PLANNING COMMISSION REGULAR DOCKET TUESDAY, March 14, 2023 at 5:30 P.M. Hybrid Meeting

ERB Staff report prepared by: Jeff Werner, AICP, Preservation and Design Planner

Submittal: Mitchel/Matthews Architects & Planners drawings for *2005 Jefferson Park Avenue Entrance Corridor Review Application*, dated December 20, 2022: Sheets 1 (cover) through 76.

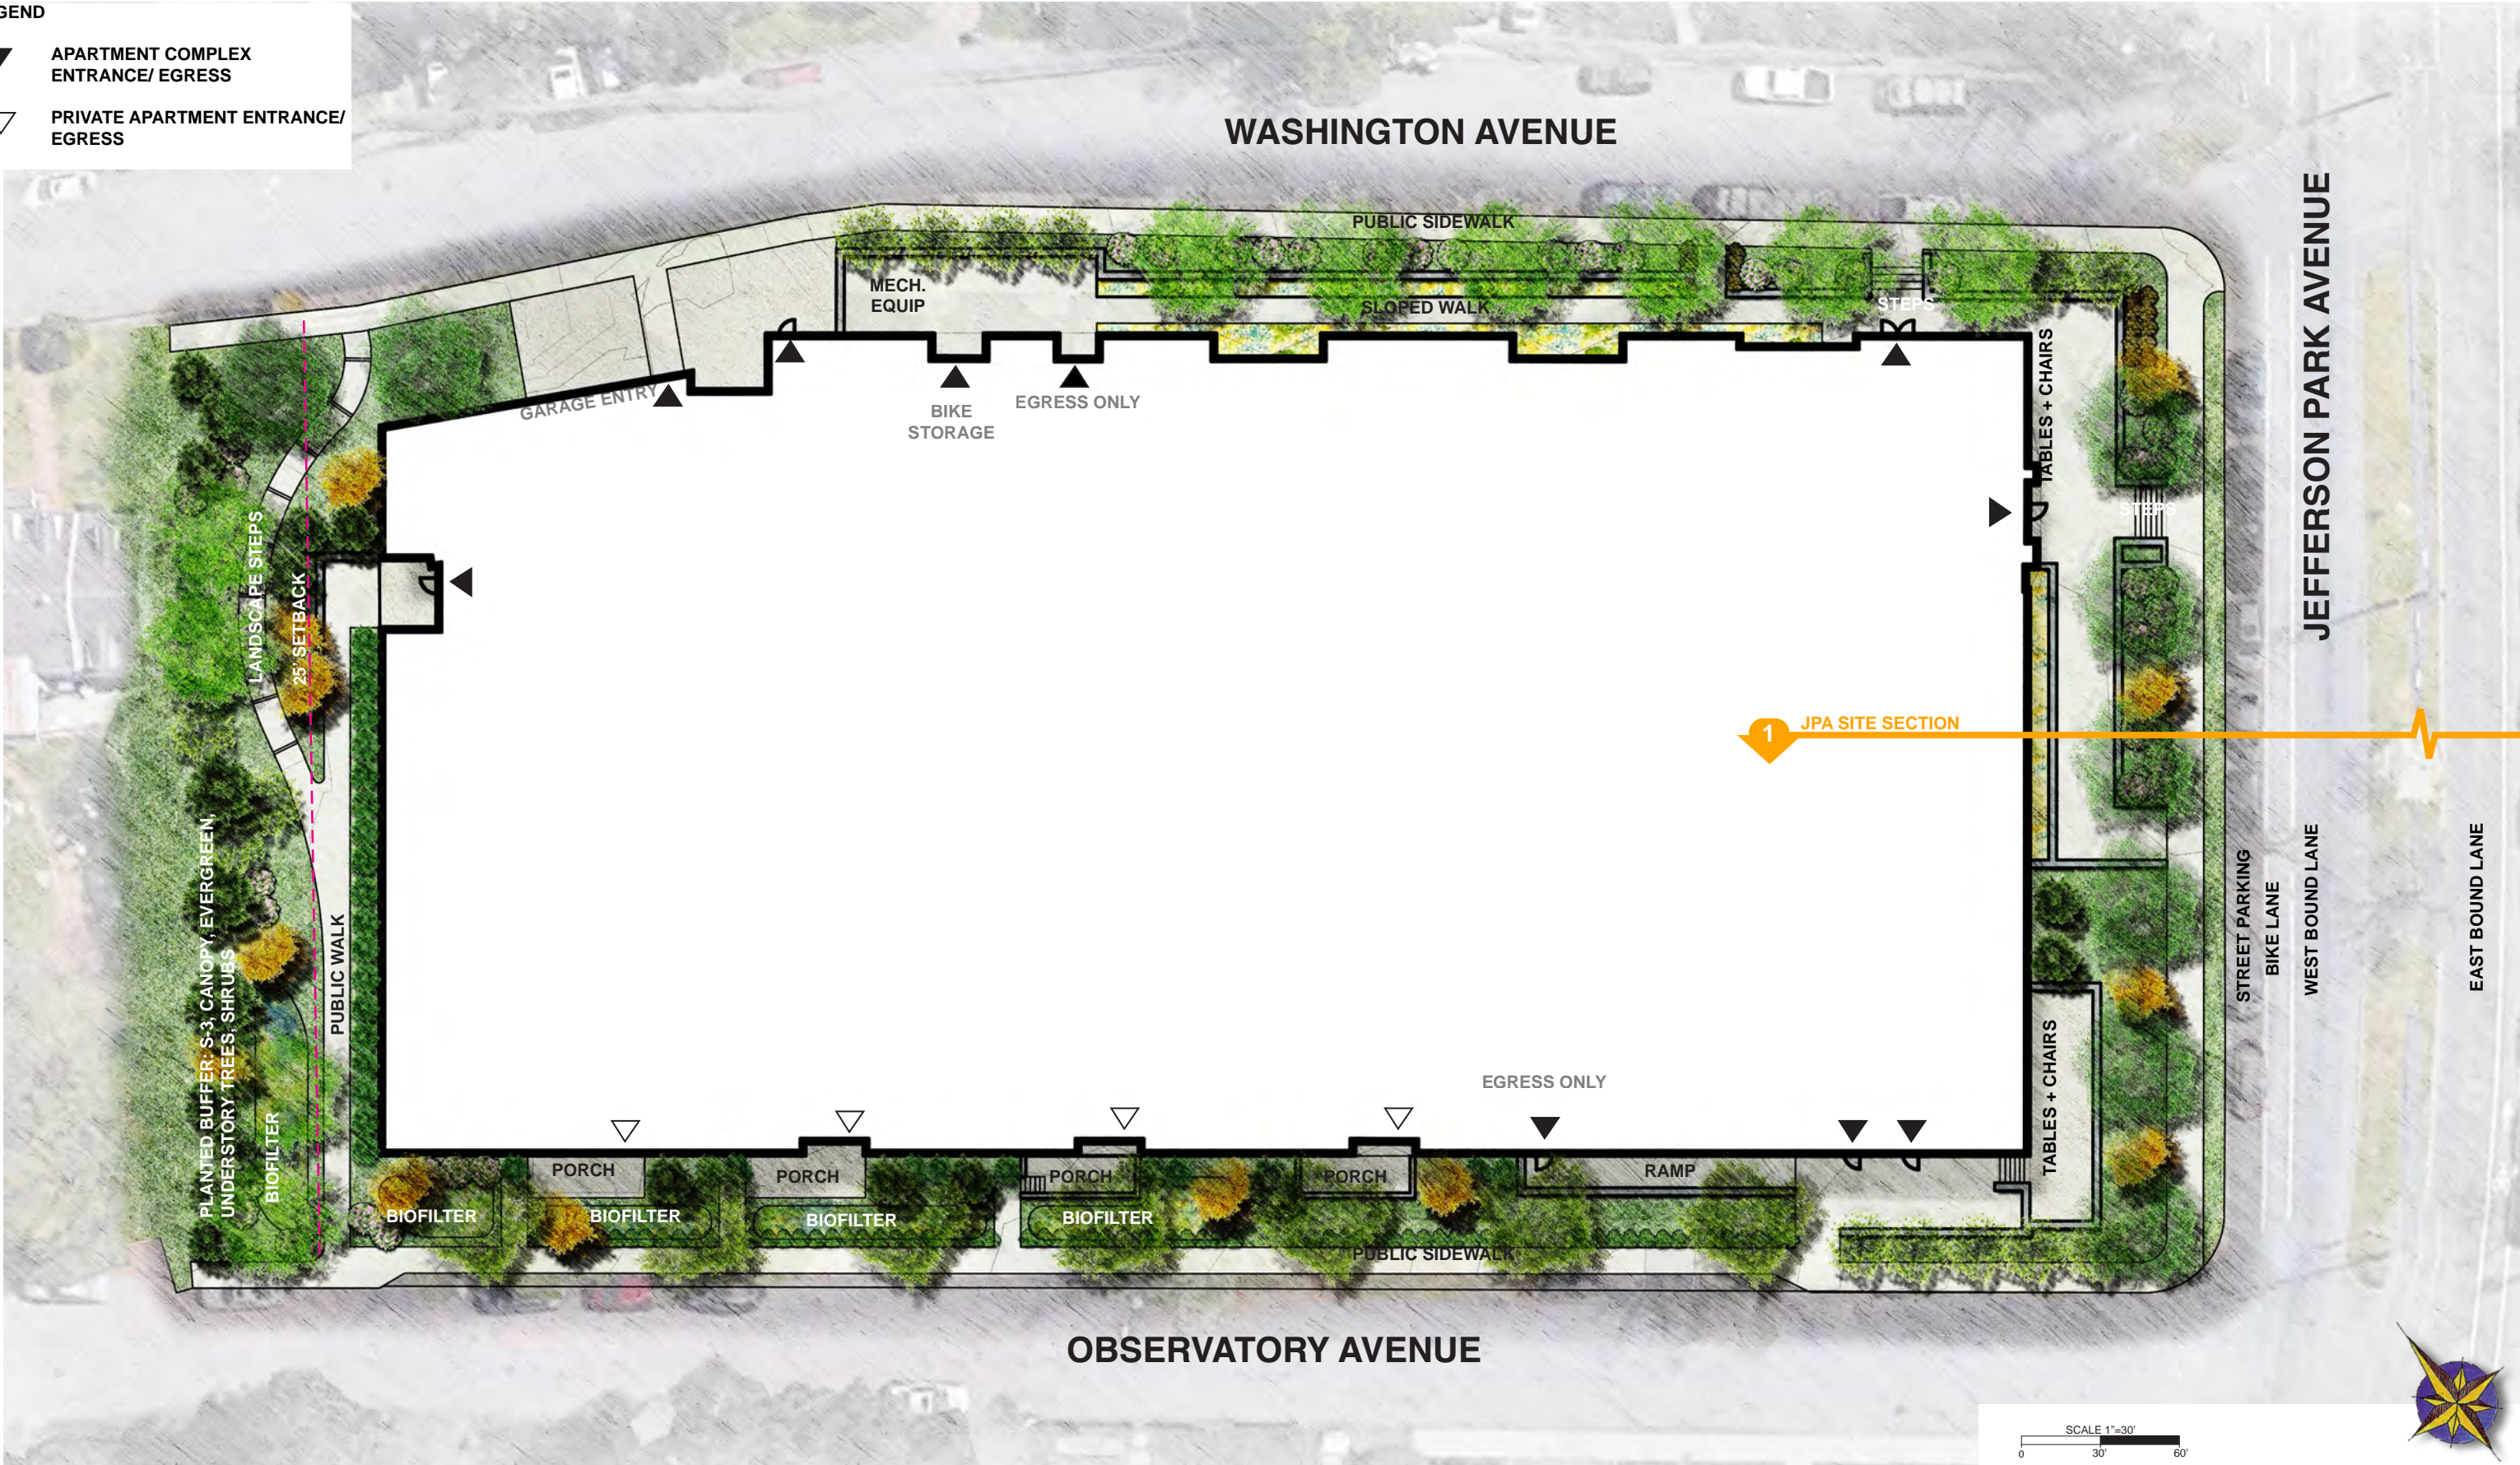
- Foundation/Podium: Red brick (Sheet 42)
- Walls:
 - Red brick (Sheet 42)
 - Stucco, painted (Sheet 42)
- Windows: PlyGem PVC, single hung, 1/1, insulated glass. Color: Black units and white units; varies per wall section. (Sheet 43)

LANDSCAPE PLAN

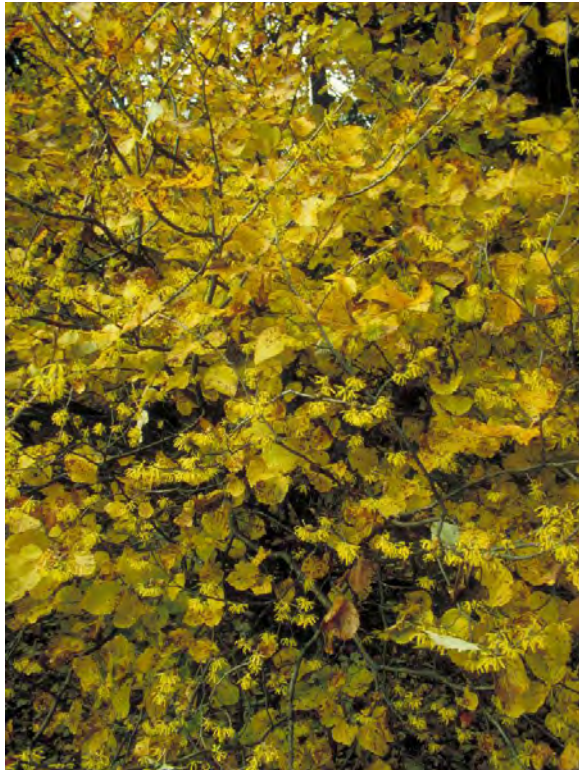
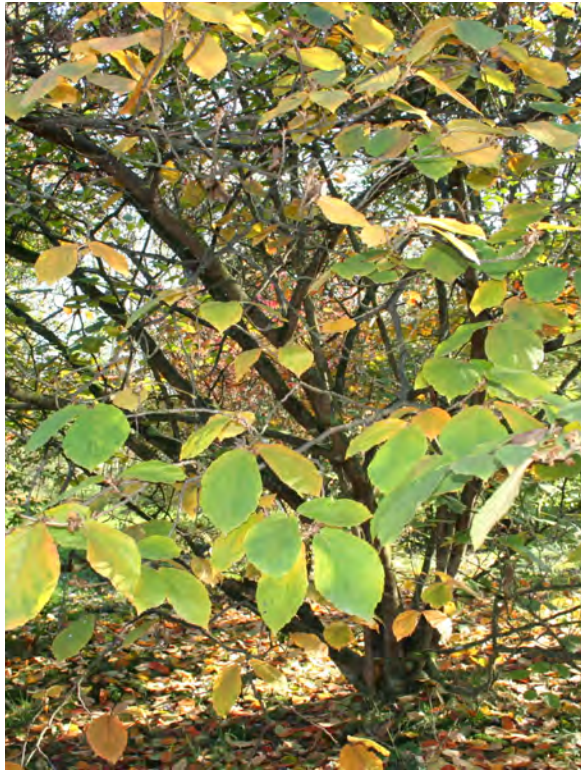
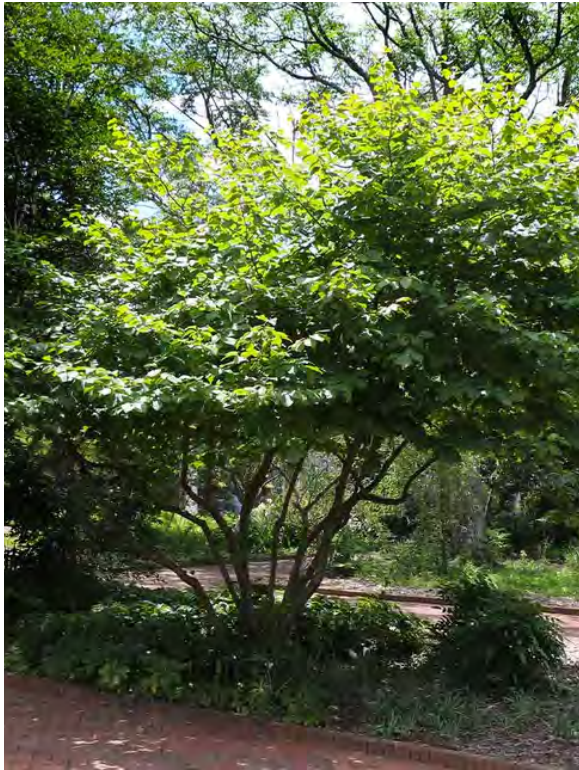
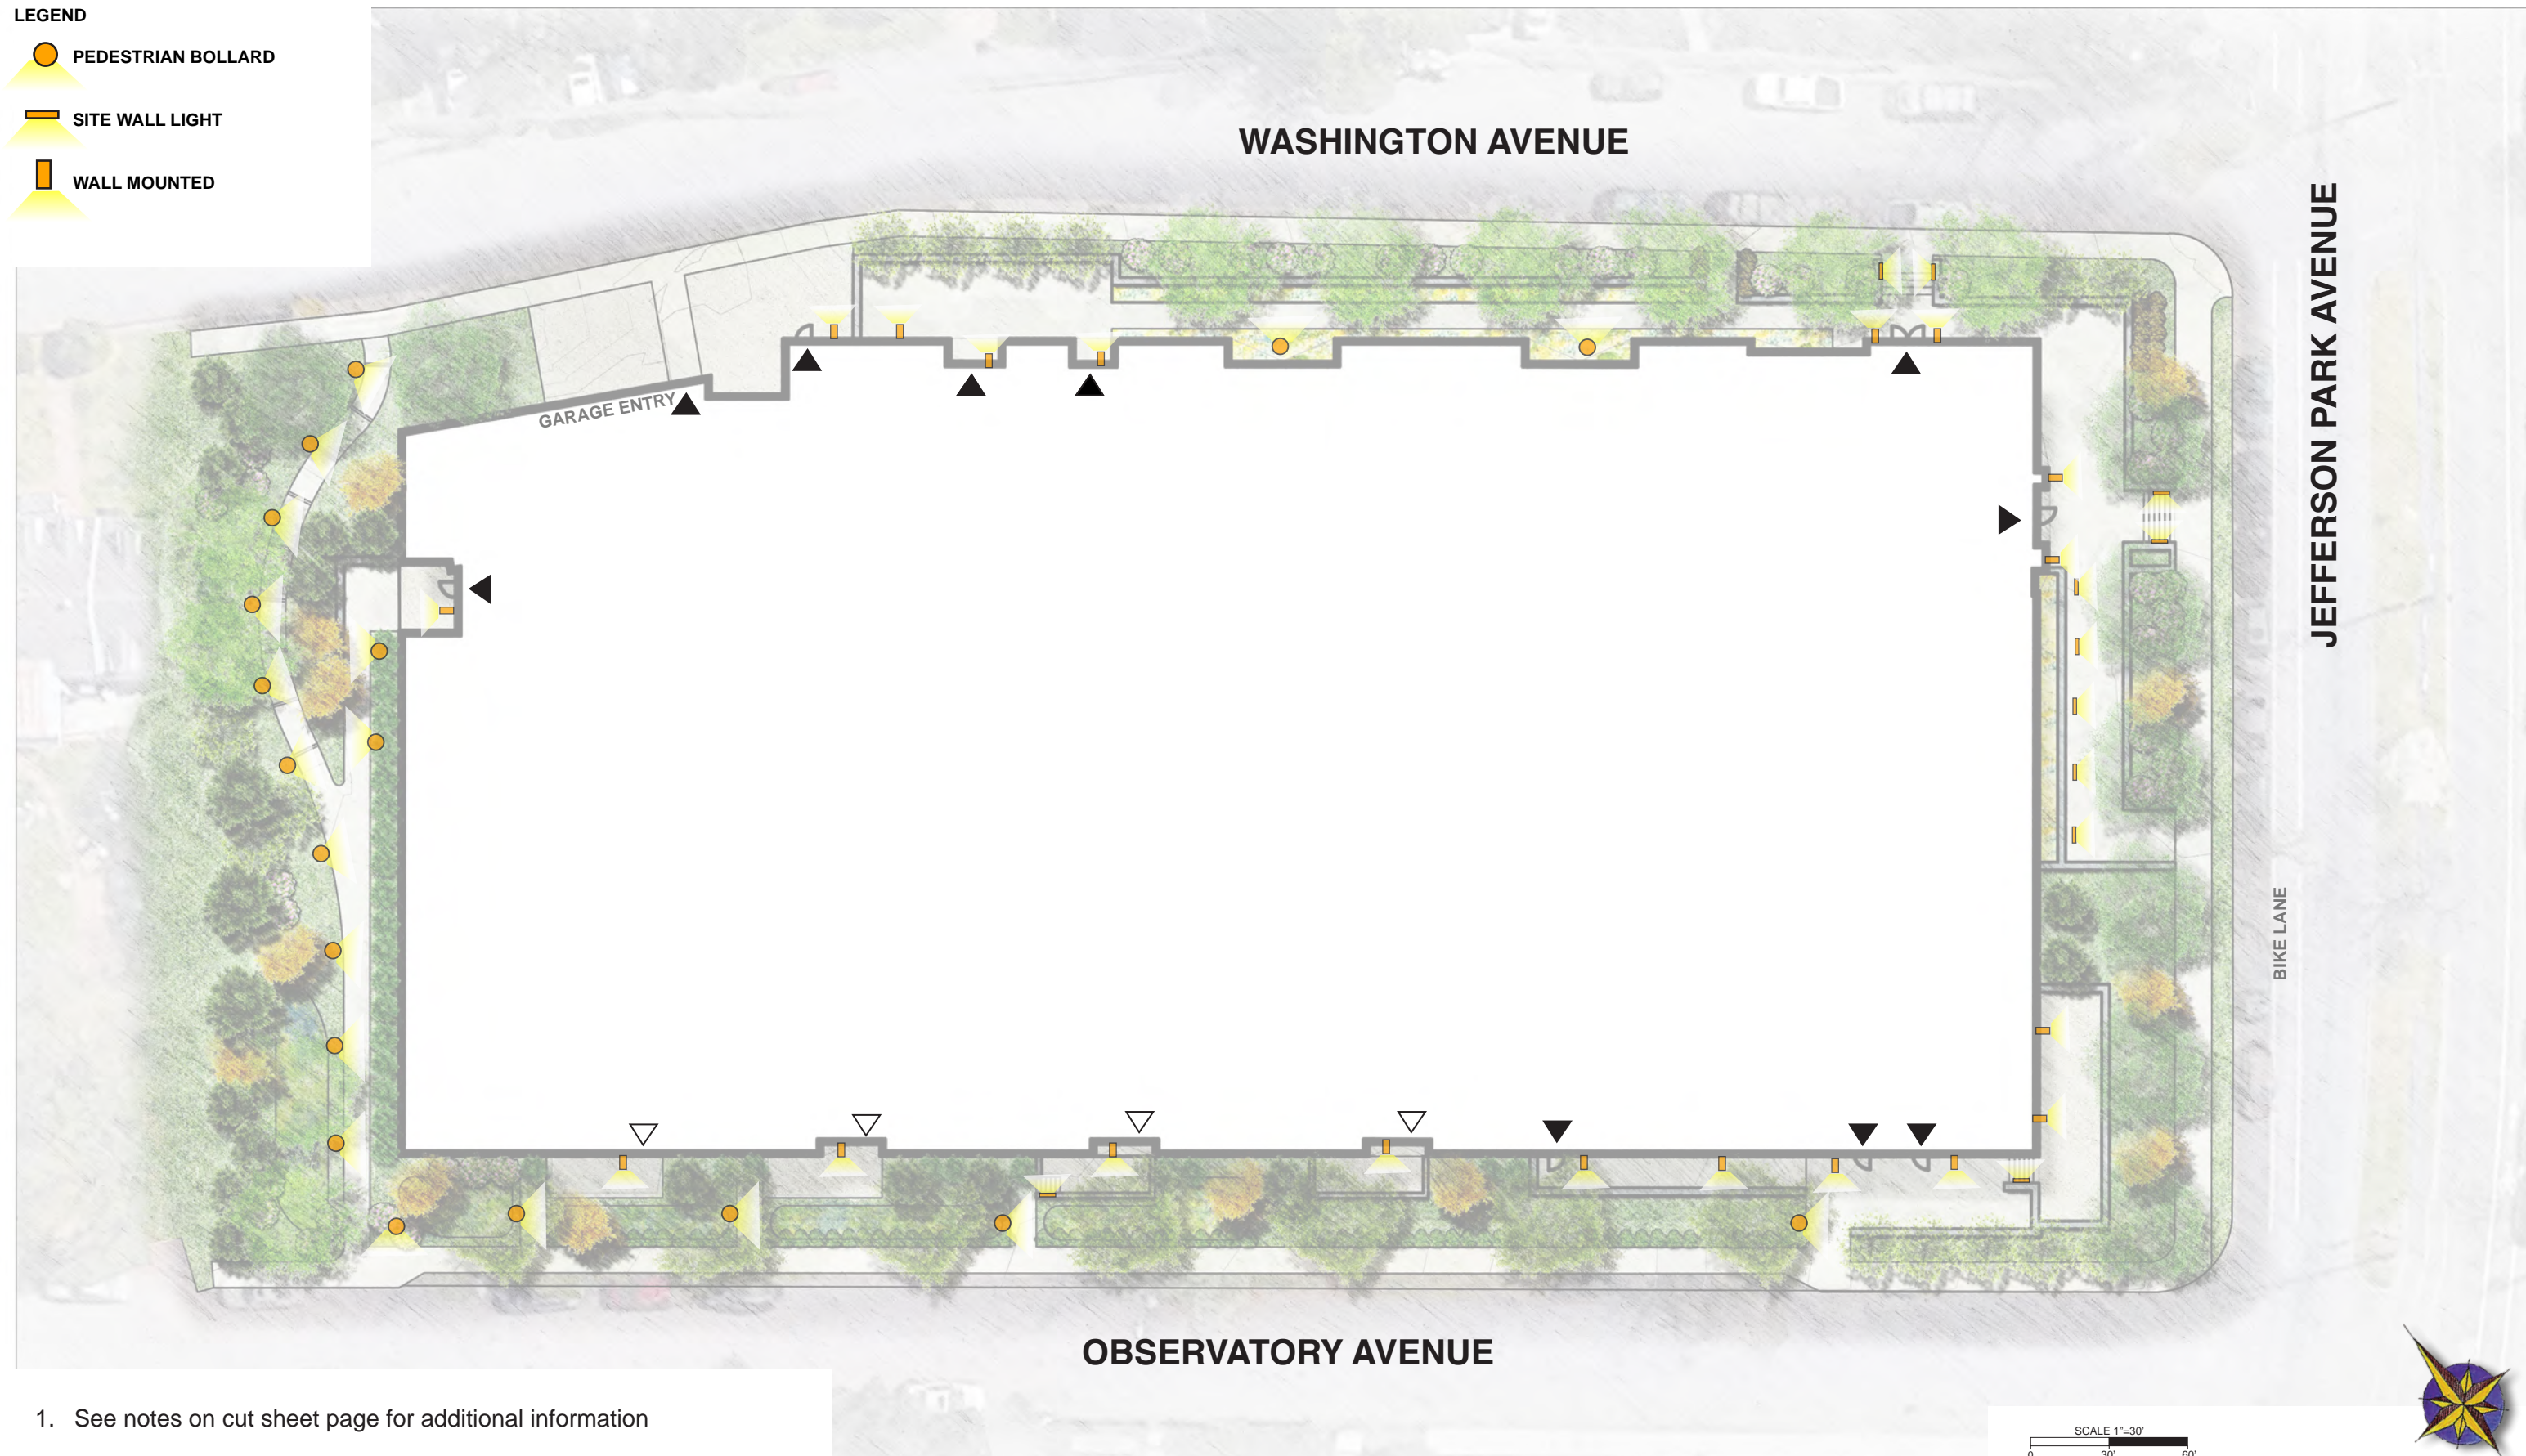
- Mechanical equipment: Rooftop units will be screened behind the parapet.
- Sheet 44 indicates an area near the garage entrance designated for Mech Equip. [Staff note: It is unclear what might be placed here or the precise location and dimensions of the brick wall; however, if used for mechanical units, utility/service boxes, storage, trash containers, etc., it will be appropriately screened. If not by the wall, then appropriate fencing or plantings.]
- Dumpsters/trash: It is understood these will be located within the garage and pulled to the curb on collection days. (Near the garage entrance, a low wall will enclose the area noted on sheet 13, so this not intended to serve as a screened enclosure.) [Staff note: Recommend a condition establishing that dumpsters and trash and/or recycling bins will be located within the garage and pulled to the curb only on collection days.]

- If used for mechanical units, utility/service boxes, storage, trash containers, the *Mech Equip* area noted on sheet 44, at the west elevation, will be appropriately screened. That screening will be subject to approval by design staff and must be memorialized as an amendment to the site plan.

- Dumpsters and trash and/or recycling bins to be located within the garage and pulled to the curb only on collection days.
- If used for mechanical units, utility/service boxes, storage, trash containers, the *Mech Equip* area noted on sheet 44, at the west elevation, will be appropriately screened. That screening will be subject to approval by design staff and must be memorialized as an amendment to the site plan.
